#### **ADDENDUM NO. 004**

Brighton Wastewater Treatment System Upgrades

June 2, 2025

2/S424 shows hooks on the base slab bars at expansion joints.

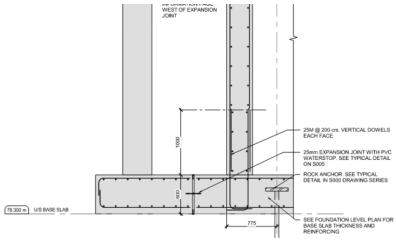
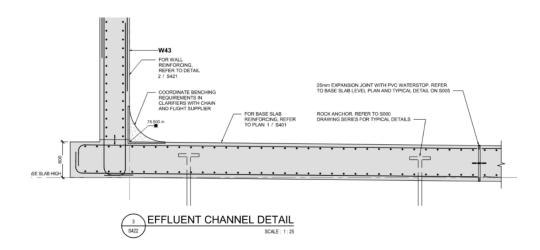
- Item No. 46 11347 1.3.1.7.8 Please note that for submittals, only generic screens can be provided. Project-specific screens will be supplied after programming is completed to ensure they are accurately reflected in the O&M manuals.
  - 46.1 Submission of generic screens with the submittal and project-specific screens with the O&M manuals is acceptable. Please note that O&M manuals must be submitted prior to equipment start-up in accordance with specification 15014.
- Item No. 47 Drawing P701 indicates both 2 and 3 access hatches and drawing S700 mentions to provide hinged grating panels.
  - 47.1 Refer to Section 11312, Item 2.5.1.
- Item No. 48 Are hooks required in base slabs at expansion joints? Section 2/S424 shows hook and there are multiple other sections that do show straight bars. See below details.

Section 1/S324, 3/S422, and 11/S005 shows straight bars

- 48.1 Straight bars can be provided in base slabs where bars terminate at locations of expansion joints.
- Item No. 49 Drawing S620. Confirm that rigid is not required under the Ferric containment slab.
  - 49.1 Per Section 2 / S010, the intent is to have free draining granular backfill under the ferric containment pad extending below frost depth. Therefore, rigid insulation would not be required.
- Item No. 50 All Structural drawings. Confirm that rigid insulation is not required under the exterior slabs.
  - 50.1 Rigid insulation is required under all exterior equipment pads as per Detail 1 / S006. Other exterior concrete slabs shall be constructed per Detail 2 / S006 or other details as applicable.
- Item No. 51 Can the following language be inserted into the contract?

DRAWING #: A-SK001

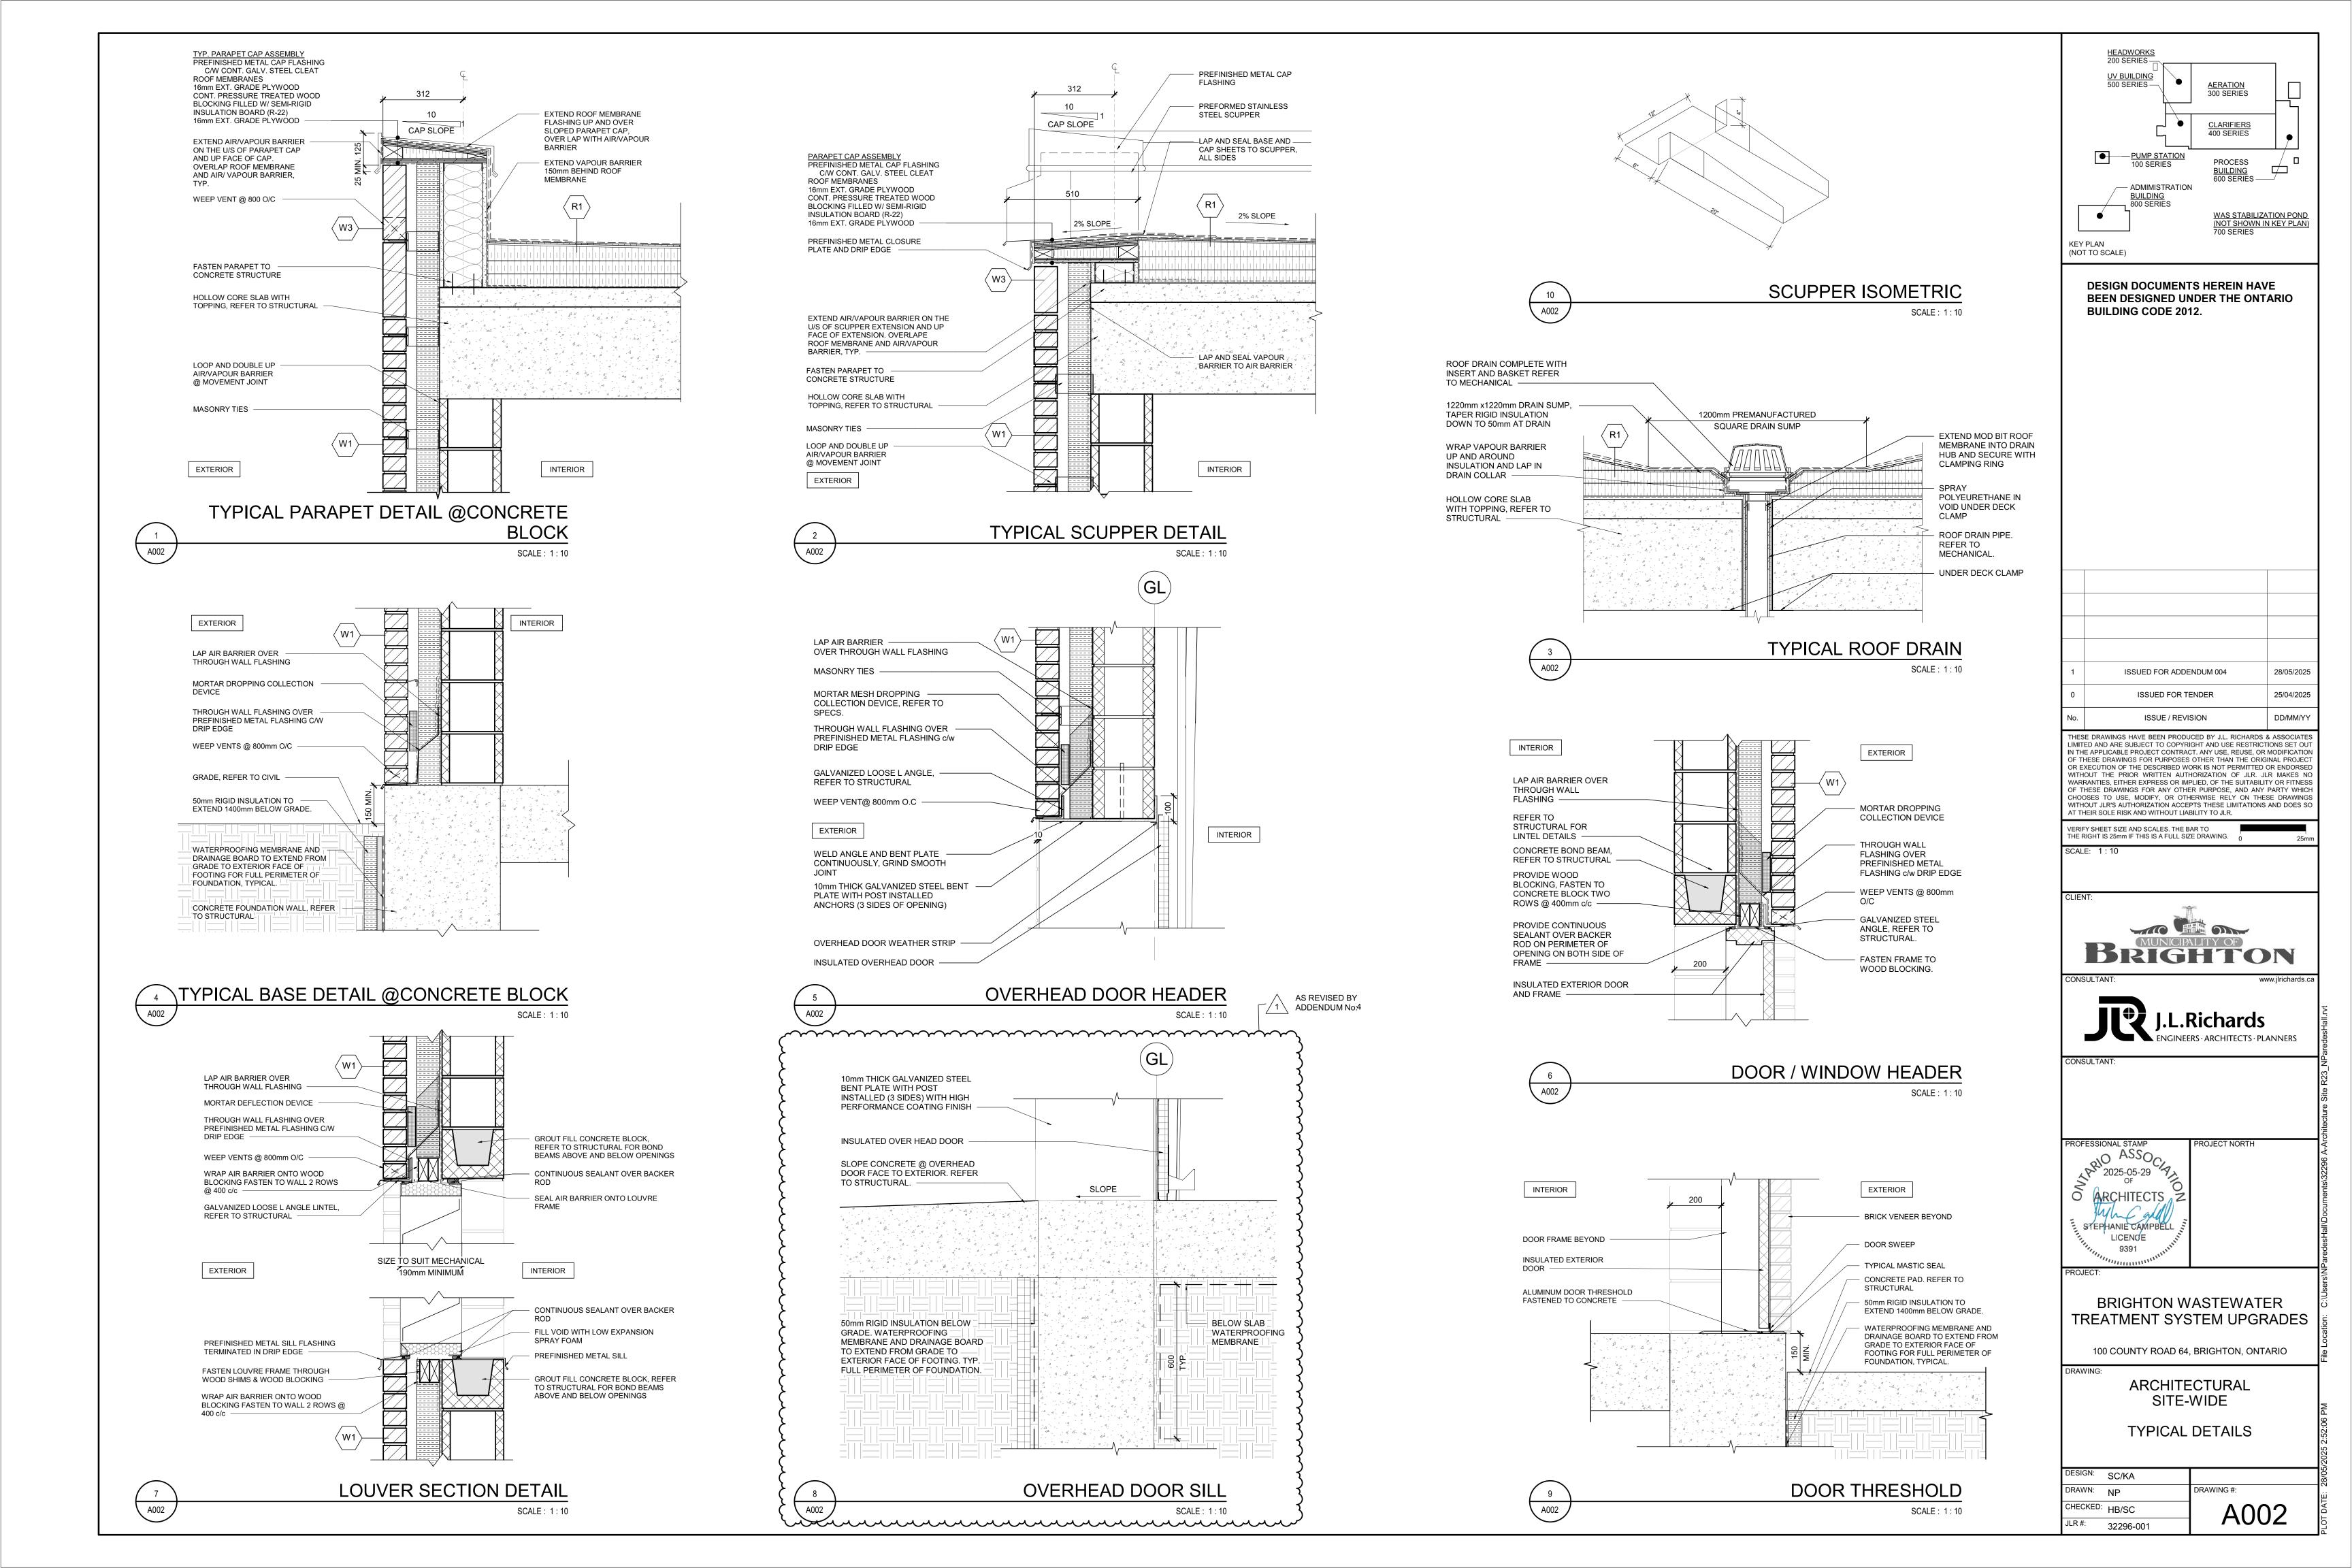
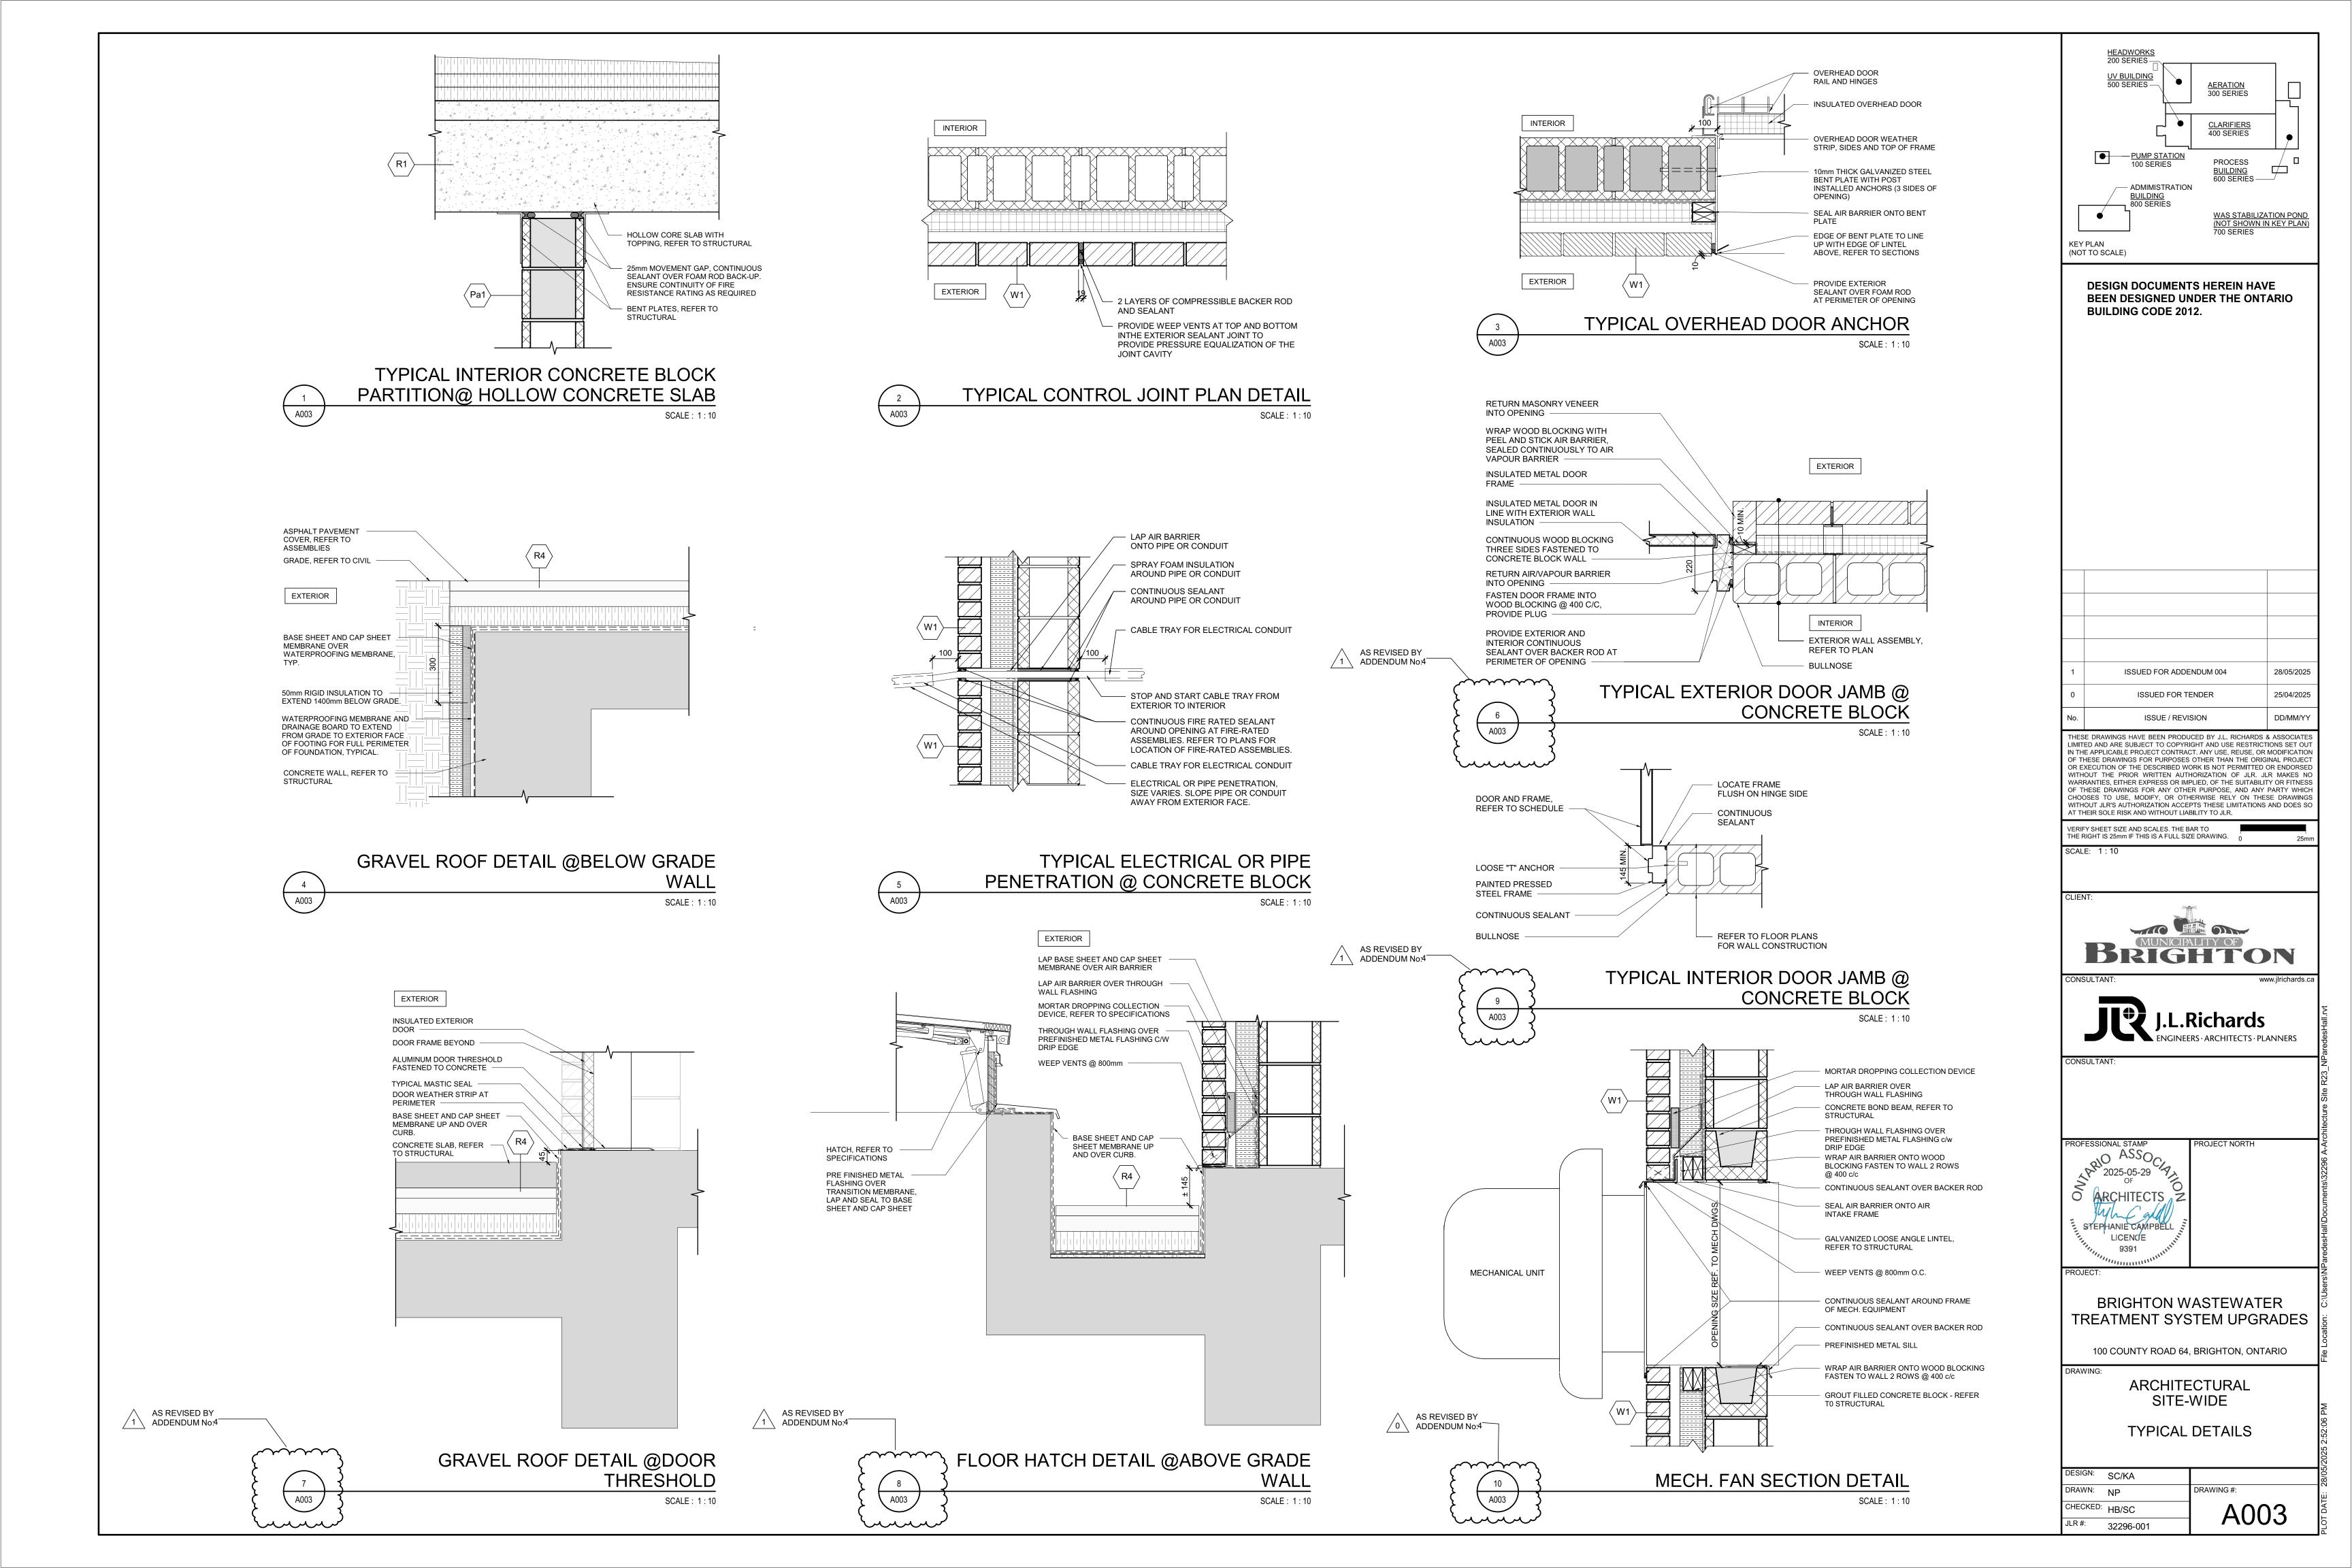
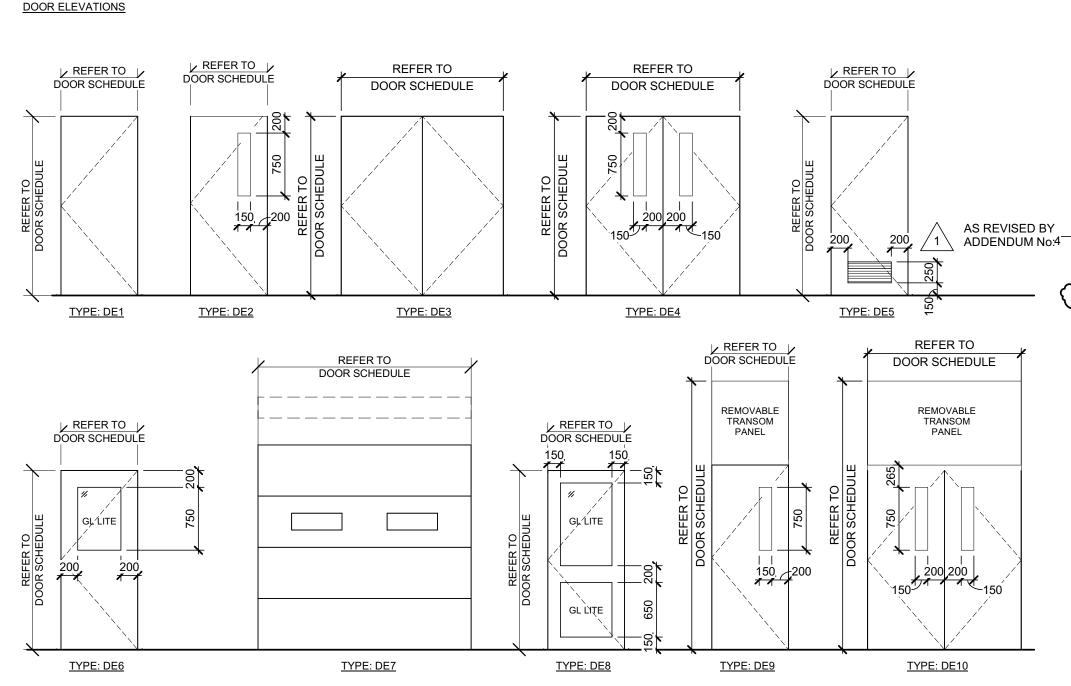
- Item No. 25 I am looking to get the list of general contractors bidding this project. Can you please provide the GC list.
  - 25.1 The sign-in-sheet from the site meeting held on May 26<sup>th</sup>, 2025 is included with Addendum No. 004.
- Item No. 26 Upon review of the architectural drawings the extent of the under slab and foundation waterproofing is very vague. Several details do not coincide with each other, or are missing details. Please review these drawings and confirm the extent of the waterproofing requirements.
  - 26.1 Refer to attached A-SK001 Site wide Waterproofing Plan to clarify under slab and foundation waterproofing extent. Refer to Addendum 004 for updated Architectural drawings.

DESIGN:	SC/KA	
DRAWN:	NP	DRAWING #:
CHECKED:	HB/SC	A005
JLR #:	32296-001

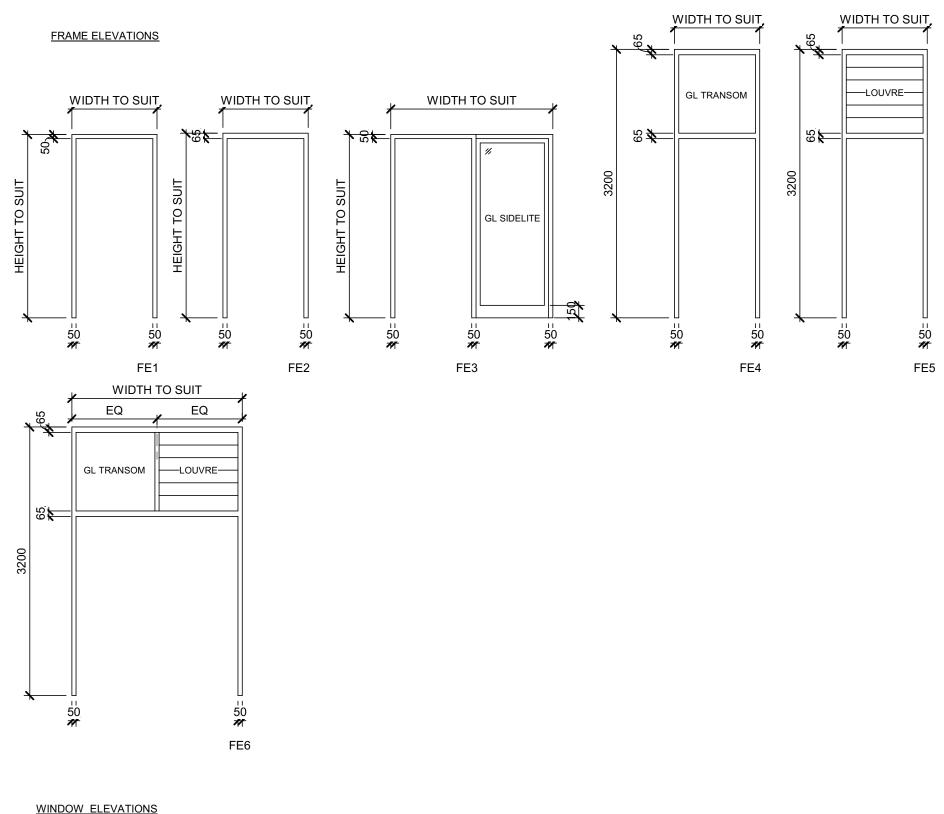
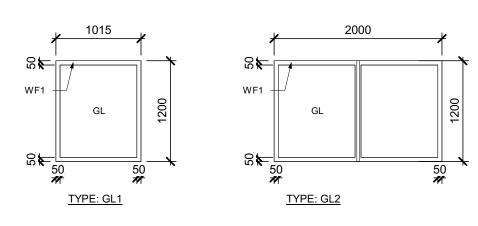
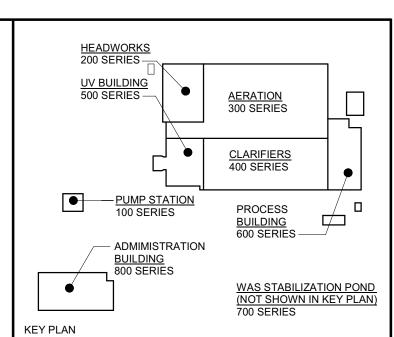
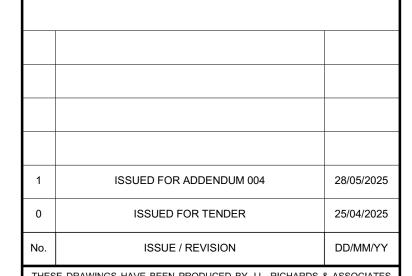
5.1 Add room 603 - Electrical room to Room Schedule.

Yes, Electrical room 603 requires Epoxy floor finish. Schedule has been updated, refer to drawing A005.
